Office - Warehouse Facilities for:
THE GRAHAM COMPANIES
BLDG 64 & 65

SITE PLAN REVIEW RESPONSES

To:	Brandon R. Schaad	From:	Jose Aguada
Company:	MIAMI LAKES	Date:	11-16-2016
Job:	GRAHAM BLDGS 64&65	Job #:	16-025
Process #	PHSP2016-0004	Re:	Application Comments

Site Plan 1"=50'

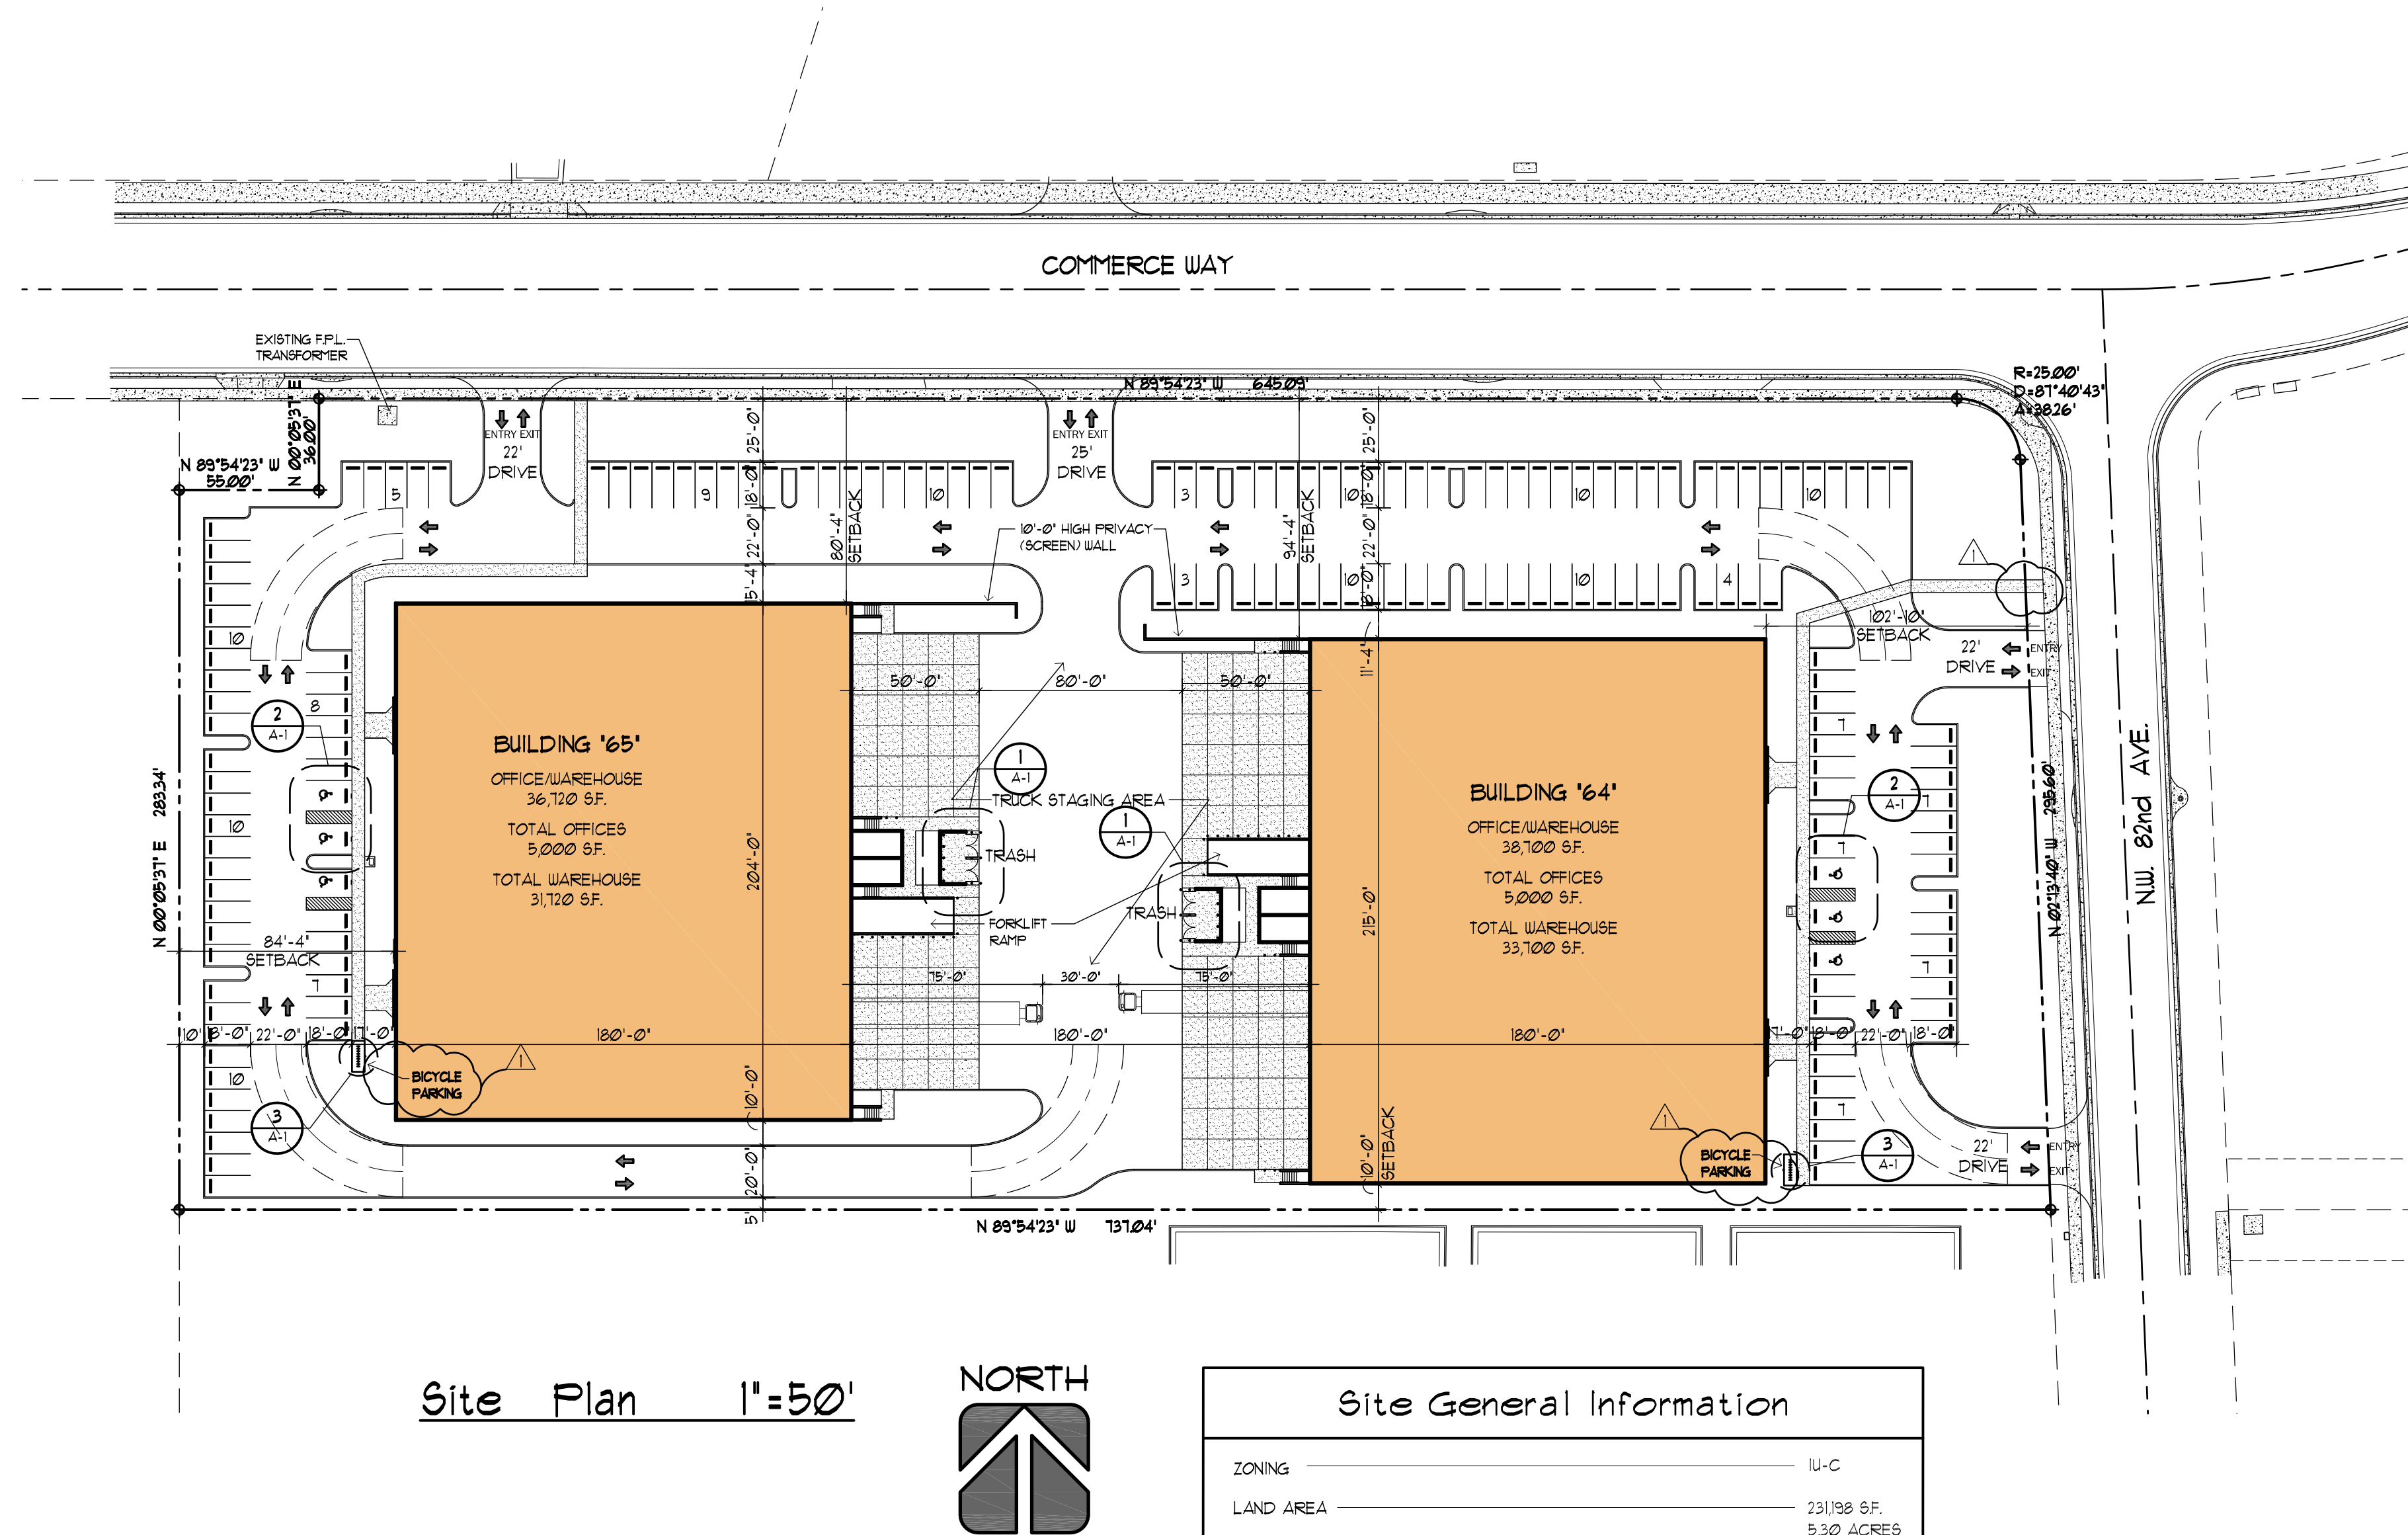
2 – Sheet A-1: call out more clearly the location of proposed bicycle parking.

Response: SEE PLANS SHEET A-1. HIGHLIGHTED "BICYCLE PARKING" AT THE FRONT NORTH OF THE BUILDING

3 – Sheet A-1: the walkway leading to the eastern property line should extend all the way to the sidewalk.

Response: SEE PLANS SHEET A-1. SIDEWALK HAS BEEN EXTENDED TO THE EXISTING SIDEWALK

4 – Sheet A-1: Site General Information table indicated that 99 parking spaces are provided for Building 64 and 72 spaces are provided for Building 65.....

Response: SEE PLANS SHEET A-1. PARKING SPACES AMOUNT REVISED TO REFLECT THE CORRECT 164 TOTAL
